CCK-2564.0-18-26 HEB BP-07

ADDENDUM #4

CCK-2564.0-18-25
Question and Response Log

SK-001.3

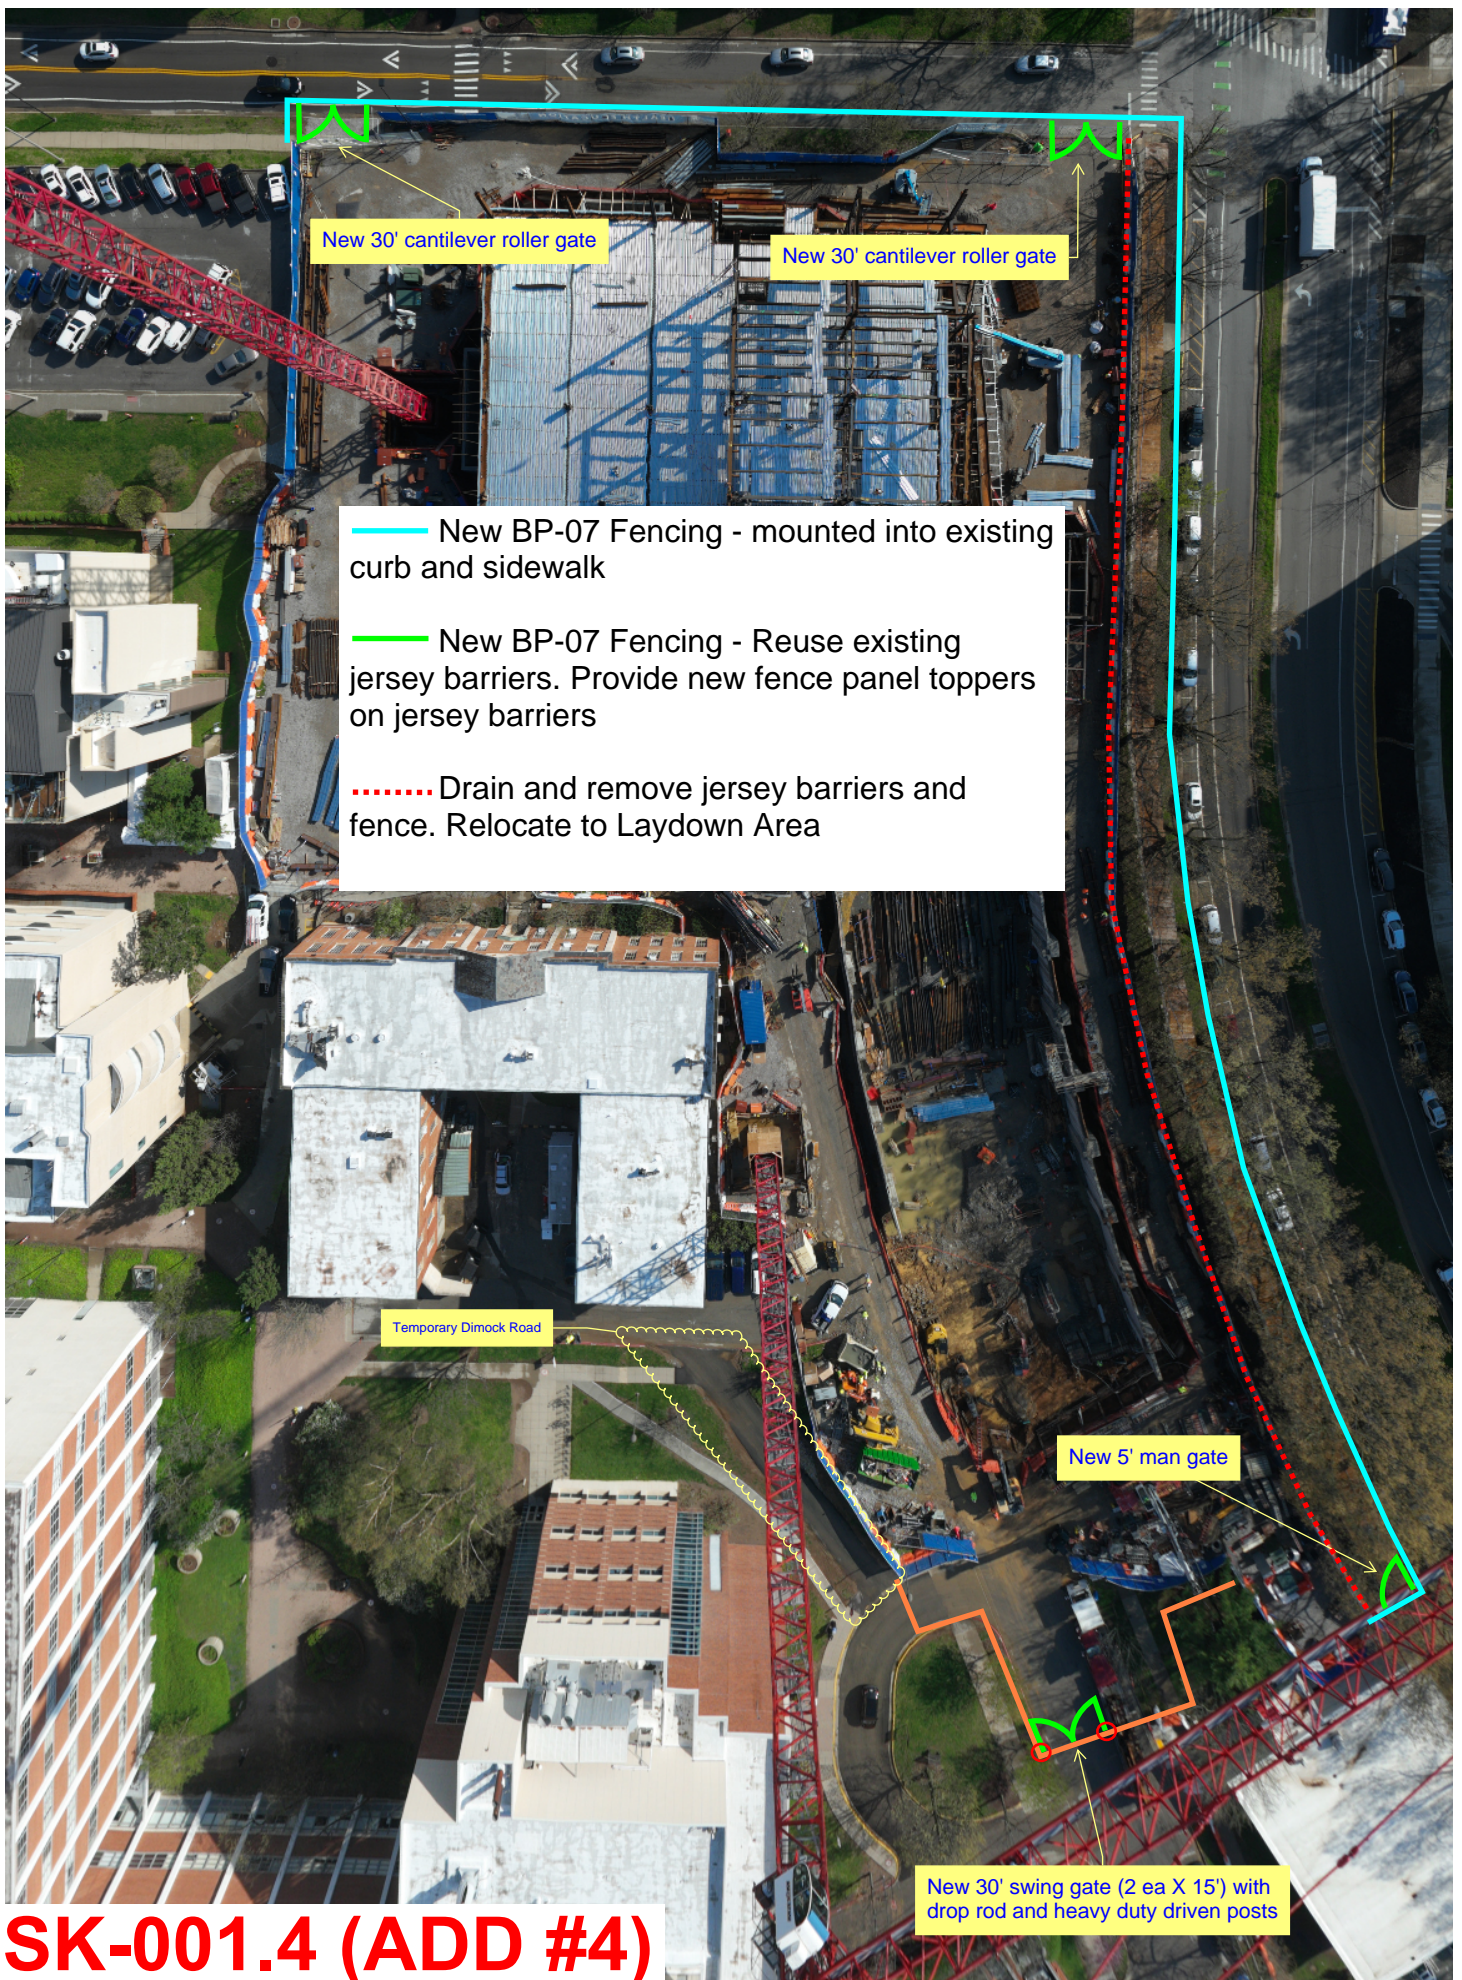
11	Will the existing south construction fence be relocated further south and if so, how far?	See updated SK-001 with new fence/gate layout.
12	It would be instrumental to develop a south gate reconfiguration plan allowing construction of the west elevation of the South Patio's earth retention system. As it stands currently, the earth retention system would be located approx. 6' from the west gate post of the south entrance, nearly against the existing 12" water main.	See updated SK-001 with new fence/gate layout.
13	There are several storm sewer runs specifically denoted as Ductile-Iron-Pipe. Elsewhere for the balance of storm sewer pipe material, may we presume that the piping material would otherwise be per spec: i.e.: PVC Cellular-Core pipe and in one location RCP? Basically wanting to confirm that DIP is not required anywhere other than its designated plan location.	Yes, DI is where specifically noted, anything not specifically DI or RCP is PVC per spec. DI is adjacent any steam lines.

16	For South Patio earth retention and excavation at the far east elevation, both will be inside the tree dripline.	See updated SK-001 with new fence/gate layout.
17	To what extent will Turner remove and/or relocate the construction fence and barricades for new construction, regardless of location?	See updated SK-001 with new fence/gate layout.
18	TC-044 is required to provide force main piping for Sump Manholes 8A & 8B. What diameter piping and who provides the pumps and electricity to those pumps?	The force main would be 2". TC-047 to provide sump pumps and power to those sump pumps in manholes 8A and 8B.
19	Item 6d. of TC-044 Scope of Work: what is meant by "multiple mobilizations to set storm drains after landscape and hardscapes are installed and at final grade"? The storm sewers would be installed first. Do you mean to set forth the periodic requirement to fine-tune the casting elevations because other trade contractors deviated from plan grades or dislodged the castings?	Include multiple mobilizations as noted to coordinate final elevations of structures with adjacent landscaping and hardscaping contractors.

New 30' cantilever roller gate

New 30' cantilever roller gate

SK-003.1(ADD#4)

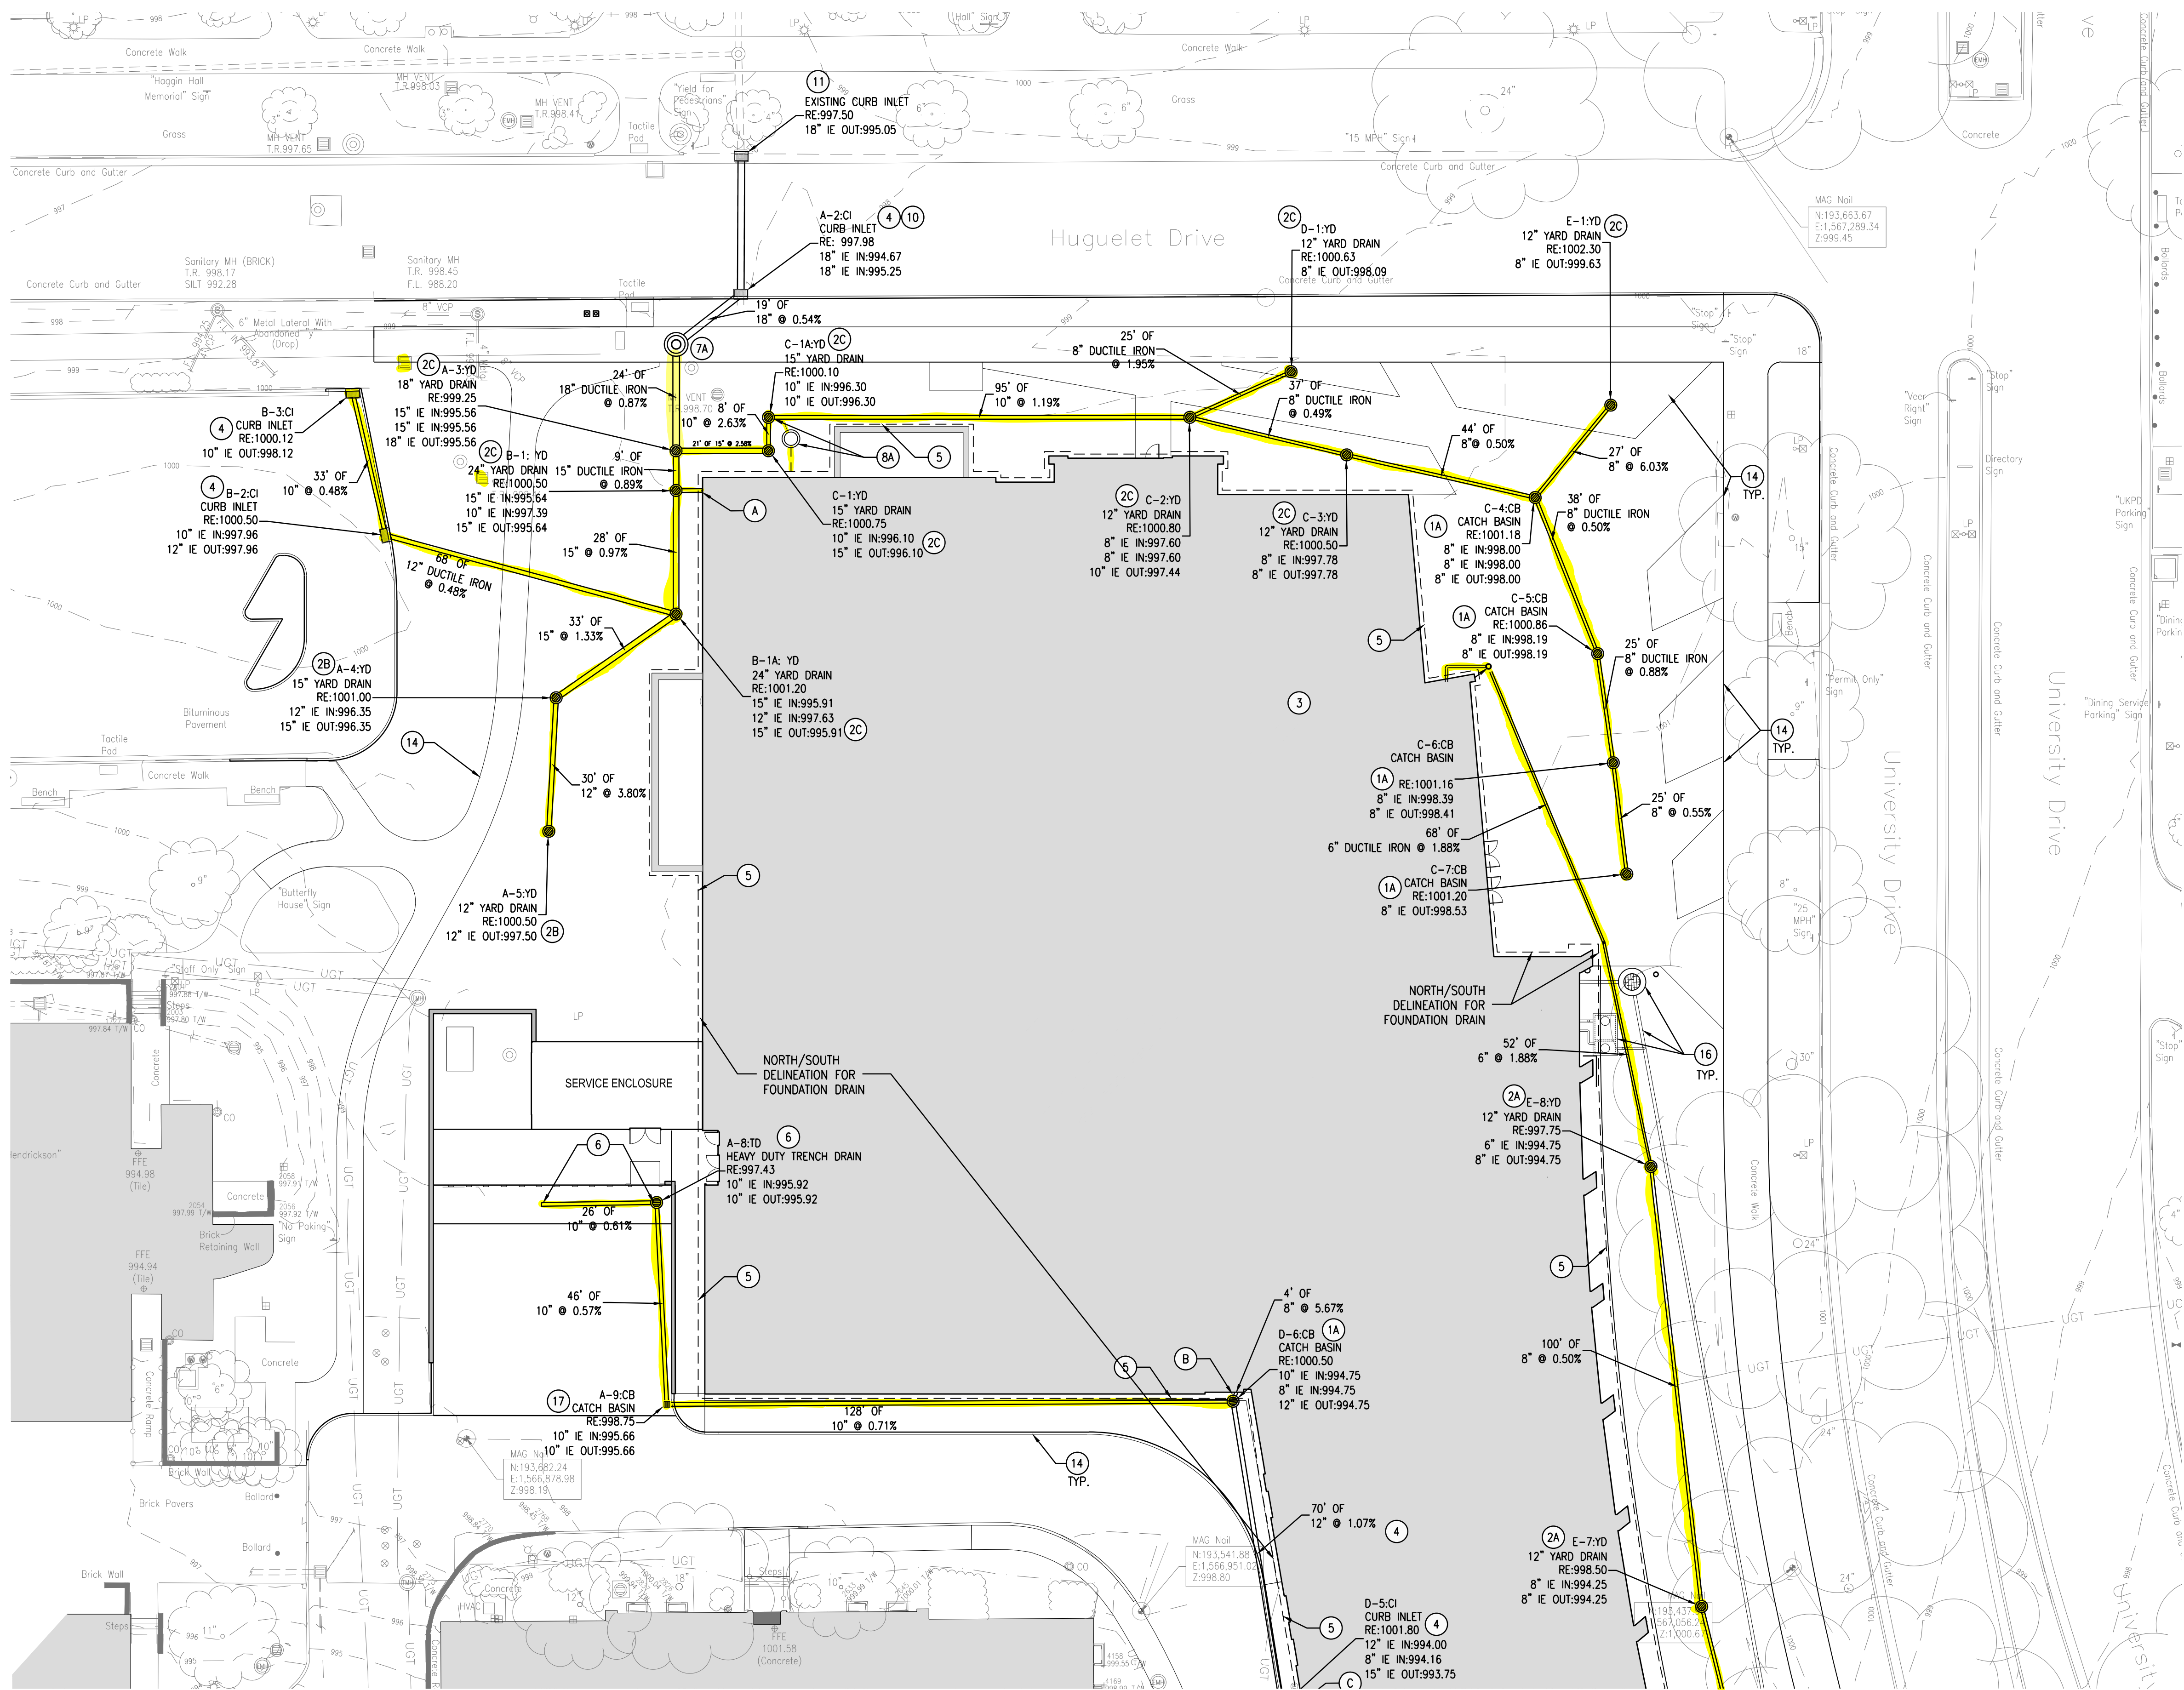
30	TC-046: With partial removal of retention system scoped, can details, plans, or description of system be provided? Types/materials of piles, tie backs, lagging, etc. This will be necessary to determine means and methods for removal.	Retentions system consists of I-Beams, Wood Lagging, 15 tie backs, and 1" thick steel plates at the top of excavation. See SK-007 for as-built of retention system.
31	TC-046: Steam lines appear to run through the loading dock and in close proximity or conflict with south patio retention wall. Are these lines installed in the locations shown?	Yes, see updated SK-005 in Addendum #3 where existing steam lines are in relation to south patio retention system. Steam lines near loading dock should run below footings.
32	SK-003.2, C601, #12: Permeable paver manhole is highlighted as TC-046 scope. Is this supposed to be included in TC-044 scope with other manholes and site drainage? Is the pump carried by previous plumbing TC's, no details are provided? Is electric included in TC-047?	TC-046 is to include permeable paver manhole as well as force main piping as shown on C601 and as shown on updated SK-003. TC-047 is to include the pump and power to the permeable paver manhole.

43	TC-046 Scope 52: If building cleaning is required, please provide details on access to perform work. Will roof tie-backs be installed for swing stages and equipment? Will an in-place window cleaning system be installed on this building? Is cleaning limited to a certain height from ground (25', 50', etc)? Are lifts permitted on hardscapes or will cleaning occur before?	See updated TC-046 scope of work for updated cleaning requirements.
44	Regarding the new fence. a. Along Huguelet this fence stays regular fencing? b. Along University it's the jersey barriers with fence? c. The new south entrance will it need to be regular fencing, or will it be the jersey barrier with fence?	See addendum #4 for updated SK-001 showing fence details.
45	In the questions, #32, the answer references an updated SK-003. I didn't see that in the addendum. Will that be issued later or is it referencing a different sketch?	See addendum #4 for updated SK-003.

HIGHLIGHTED AREAS INDICATE STORM STRUCTURES AND PIPING TO BE INSTALLED AS PART OF BP-07.
